21555 Non-Transparent PCI-to-PCI Bridge

Datasheet

21555 Non-Transparent PCI-to-PCI Bridge

Specification Update

Figure 6. 304 PBGA (Four-Layer) Package

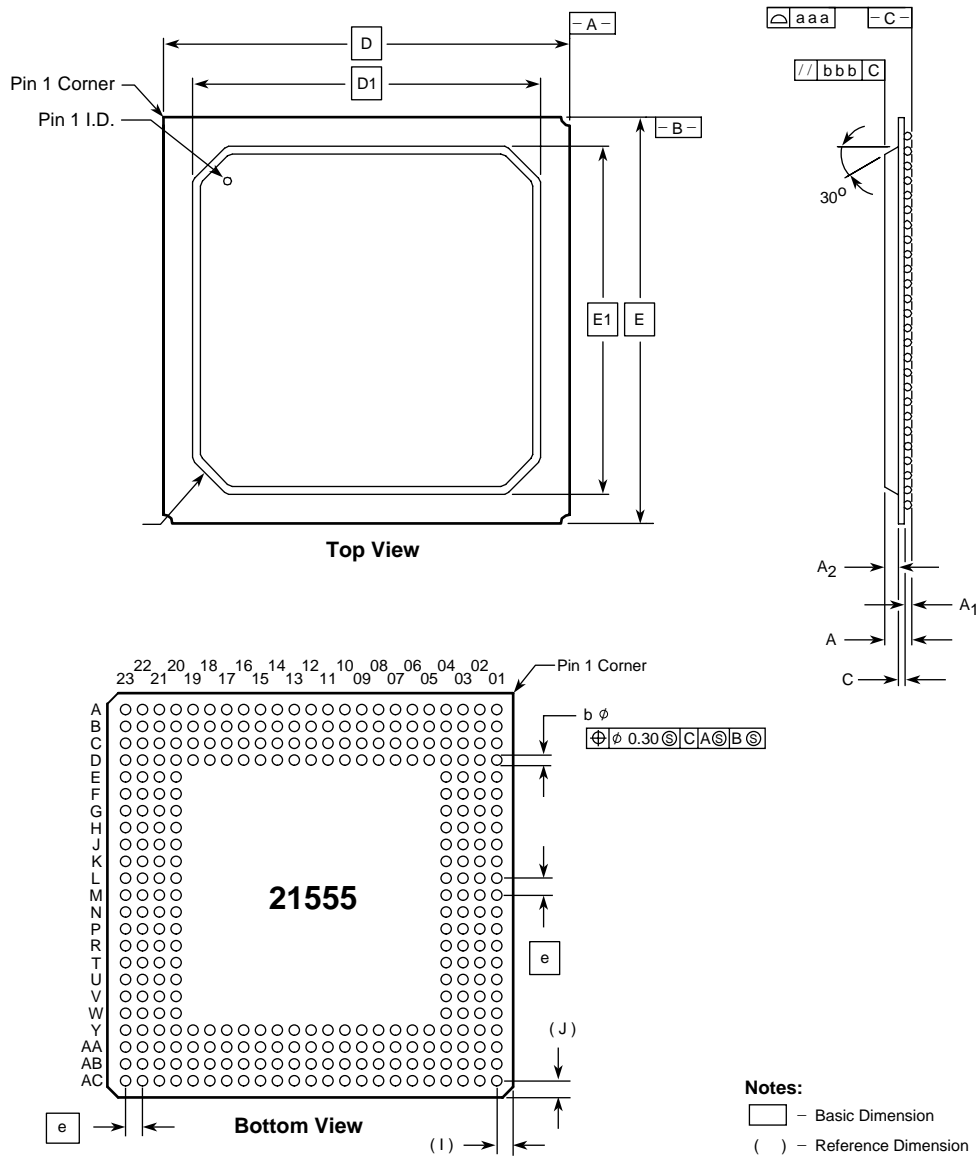
1. **PBGA Package Dimensions for coplanarity changed from maximum value 0.15 mm to maximum value 0.2 mm.**

Per PCN notification 961, the 304-point 4-layer PBGA package dimensions for symbol aaa, coplanarity, are changed from maximum value 0.15 mm to maximum value 0.2 mm.

Issue: The maximum value for symbol aaa, dimension coplanarity, has been changed from 0.15 mm to a value of 0.2 mm.

Figure 1. Node Boundary

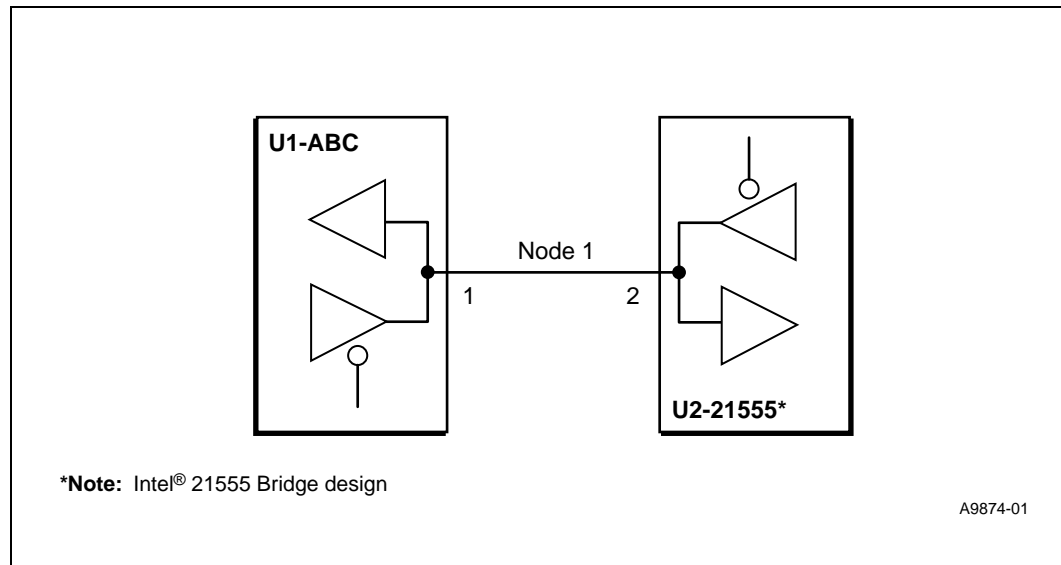
Workaround 2: Standalone boundary scan testers and In-Circuit testers performing chained boundary scan tests, should understand that the Parallel Output UPDATE data, being delayed by one clock, may cause bus contention and back driving during that one clock period, assuming the vectors change bus driving sources in one vector. This is because in chained boundary scan tests, all components execute TAP instructions in Parallel (or lock step), and vector generation algorithms optimize the number of vectors.

To understand the potential issue in detail, refer to the diagram below. Node 1 is a bi-directional node, with U1.1 and U2.2 connected as shown. Assuming that U1 is an IEEE1149.1 compliant device, that U2 is the 21555, and that the control cells of the 21555 were set during the vectors to enable the driver of U2.2 to drive to U1.1 (receiver). When switching drivers from U2 to U1, U2 should tri-state its driver prior to, or at the same time as, U1 enables its driver. Since the 21555 UPDATES its Parallel Outputs one clock late and the control cells which enable U2's drivers are Parallel Outputs which again updates one clock cycle late then U2.2, which will be driving at the same time U1.1 is driving. This contention will happen for one TCK cycle, until U2 UPDATES its parallel outputs. The period of this contention is dependent on the TCK frequency rate.

A remedy to the 21555's late UPDATE is to ensure the chained Boundary Scan tester's vectors do not switch bus driver directions in one vector. This means that one vector should disable U2's driver, and the next vector should enable U1's driver. ATPG vectors typically are not manually manageable in this way and this requirement may force an engineer's manual intervention. No single stepping of test clock through the TAP State Machine should be allowed with the 21555 in the boundary scan chain. The resulting contention would increase the potential back drive time, increasing the possibility of device damage.

Status: Fixed. This behavior has been corrected in the 21555AB/BB Step A3 device.

Figure 12-1. Signal trst_I States

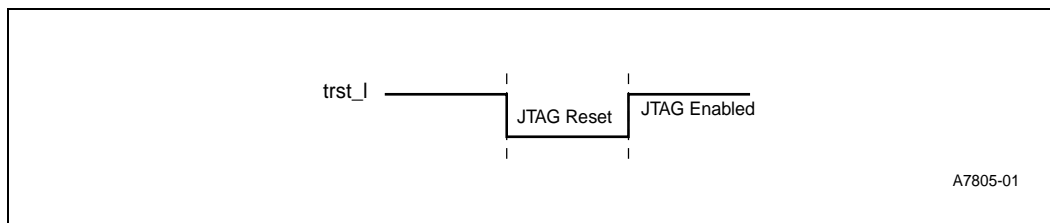
13. Change to Initialization Section 12.2.1 and JTAG Description

Issue: Change to second paragraph. Also made a change to normal operation description note for JTAG below Figure 12-1. The section now appears as follows:

The test access port controller and the instruction register output latches are initialized and JTAG is disabled while the **trst_I** input is asserted low (see Figure 12-1). While signal **trst_I** is low, the test access port controller enters the test-logic reset state. This results in the instruction register being reset which holds the bypass register instruction. During test-logic reset state, all JTAG test logic is disabled, and the device performs normal functions. The test access port controller leaves this state only after **trst_I** (low) goes high and an appropriate JTAG test operation sequence is sent on the **tms** and **tck** pins.

For the 21555 to operate properly, the JTAG logic must be reset. The controller resets:

- Asynchronously with the assertion of **trst_I**.
- Synchronously after five **tck** clock cycles, with **tms** held high.

Note: Prior to normal 21555 operation, this signal must be strobed low or pulled low with a 1kΩ resistor.
